WASHINGTON PUBLIC POWER SUPPLY SYSTEM

WPPSS NUCLEAR PROJECT NO. 2

AMENDMENT TO FACILITY OPERATING LICENSE

Amendment No. 45
License No. NPF-21

Figure 3.2.1-3

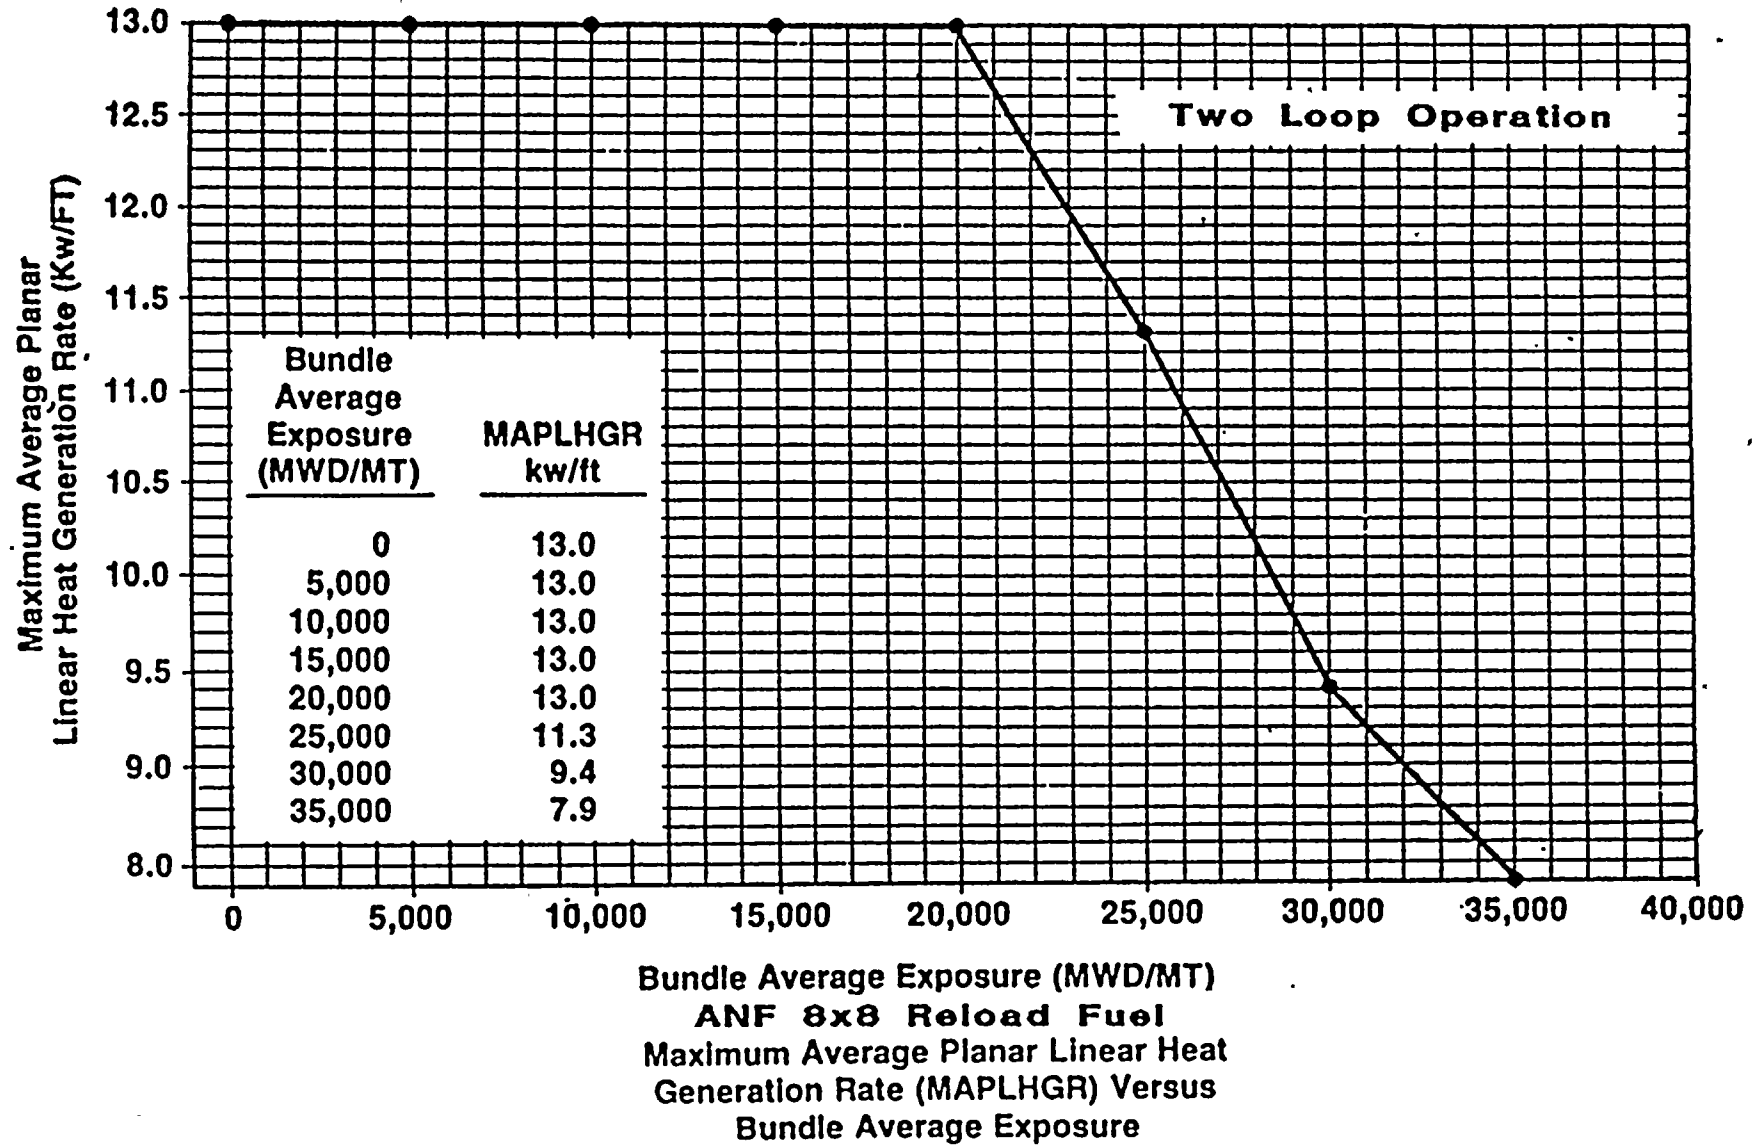
3.2.1 All AVERAGE PLANAR LINEAR HEAT GENERATION RATES (APLHGRs) for each type of fuel as a function of AVERAGE PLANAR EXPOSURE for GE fuel and average bundle exposure for ANF fuel shall not exceed the limits shown in Figures 3.2.1-1, 3.2.1-2, and 3.2.1-3 when in two loop operation, and Figures 3.2.1-4, 3.2.1-5, and 3.2.1-6 when in single loop operation.

With an APLHGR exceeding the limits of Figure 3.2.1-1, 3.2.1-2, or 3.2.1-3 in two loop operation or Figure 3.2.1-4, 3.2.1-5, or 3.2.1-6 in single loop operation, initiate corrective action within 15 minutes and restore APLHGR to within the required limits within 2 hours or reduce THERMAL POWER to less than 25% of RATED THERMAL POWER within the next 4 hours.

Figure 3.2.4-1

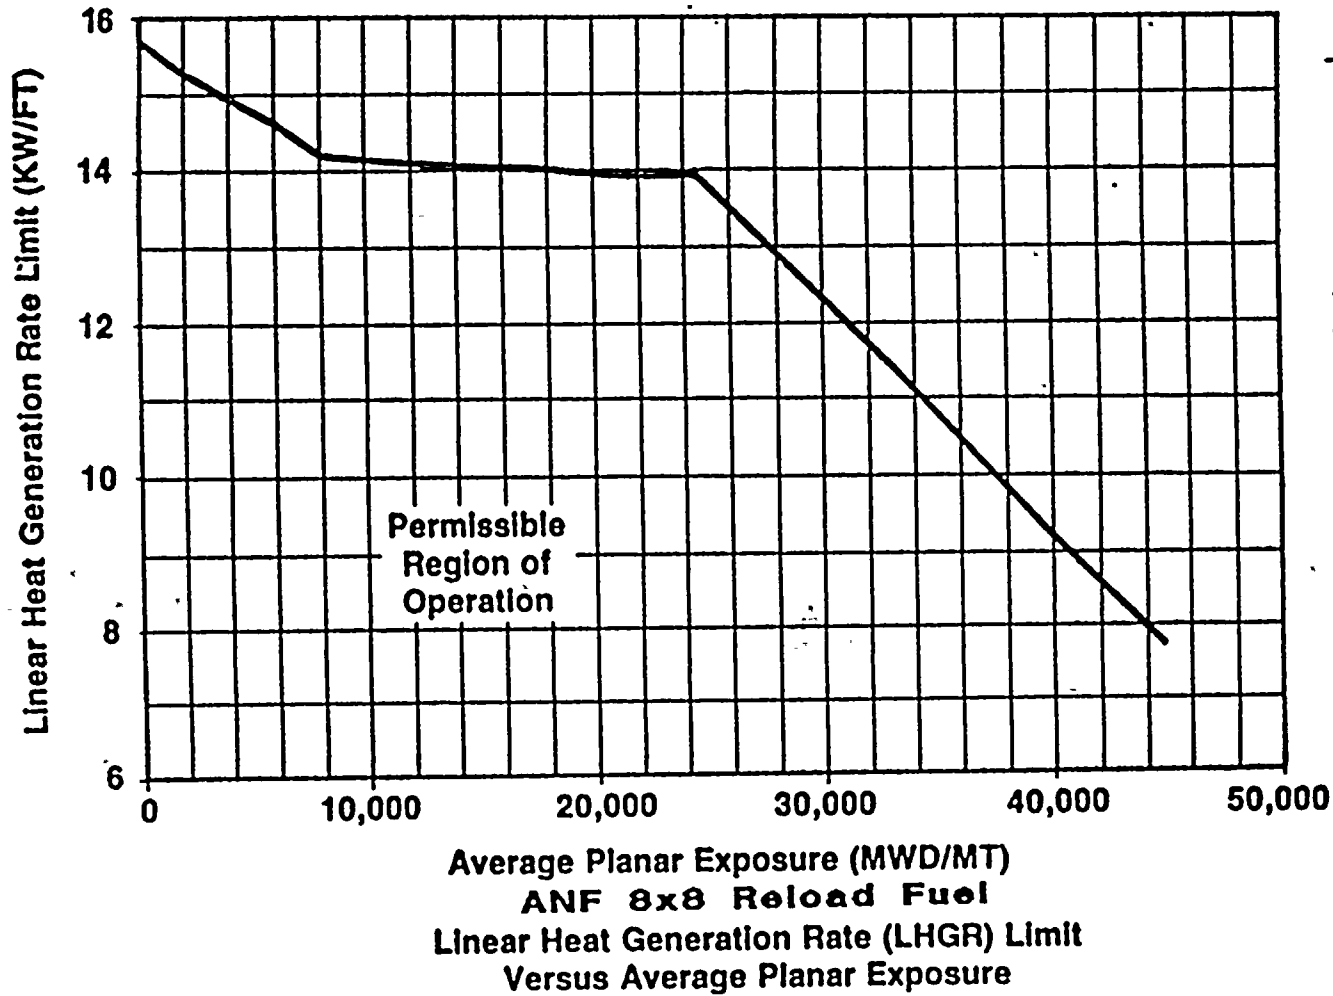
3.2.4 The LINEAR HEAT GENERATION RATE (LHGR) for GE fuel shall not exceed 13.4 kW/ft. The LHGR for ANF fuel shall not exceed the values shown in Figure 3.2.4-1.

<u>EXP</u>	<u>LHGR</u>
0	15.62
510	15.621
2,580	15.10
5,230	14.71
7,940	14.19
10,470	14.13
13,220	14.06
15,990	14.06
18,708	14.00
21,590	13.93
24,420	13.93
27,280	13.08
30,150	12.24
33,050	11.40
35,960	10.47
38,900	9.55
41,830	8.65
44,760	7.77

Thermal Power Limits of Specification 3.3.10-1
Figure 3.3.10-1

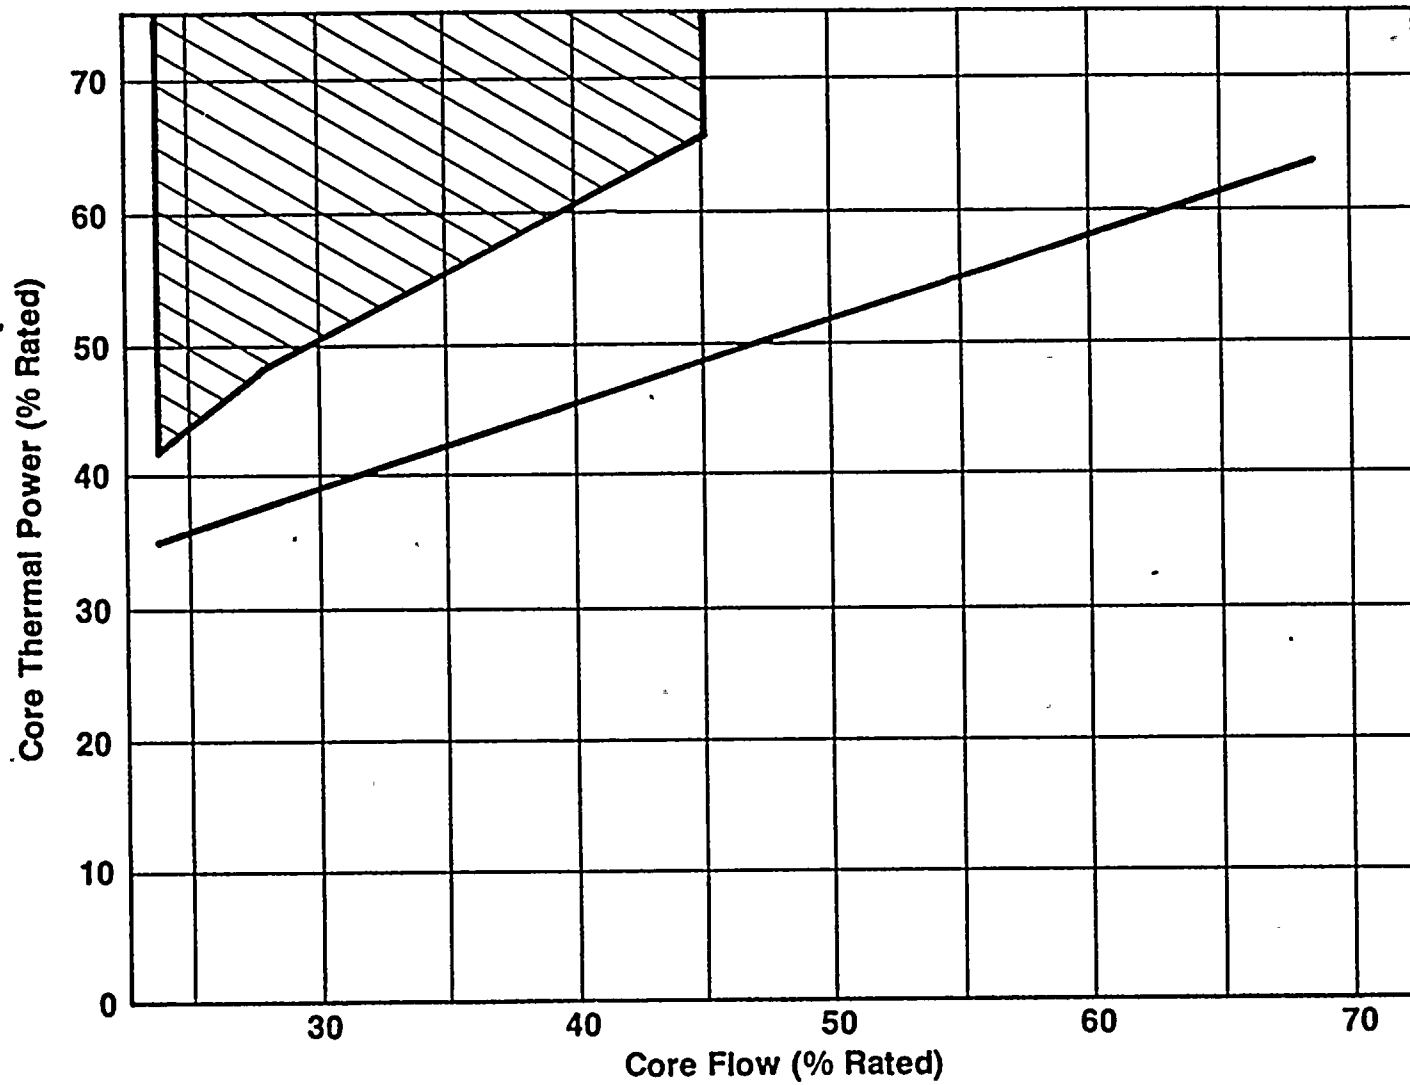
3.3.10 The APRM and LPRM* neutron flux noise levels shall not exceed three (3) times their established baseline values when operating in the allowable region of Figure 3.3.10-1.

APPLICABILITY: OPERATIONAL CONDITION 1 with two reactor coolant system recirculation loops in operation with THERMAL POWER greater than the limit specified in Figure 3.3.10-1 and total core flow less than 45% of rated total core flow or with one reactor coolant system recirculation loop not in operation with THERMAL POWER greater than the limit specified in Figure 3.3.10-1.

4.3.10.4 The APRM and LPRM* neutron flux noise levels shall be determined to be less than or equal to the limit of Specification 3.3.10 and the reactor power/core flow shall be verified to lie outside the crosshatched region of Figure 3.3.10-1 when operating within the APPLICABLE OPERATIONAL CONDITION of Specification 3.3.10:
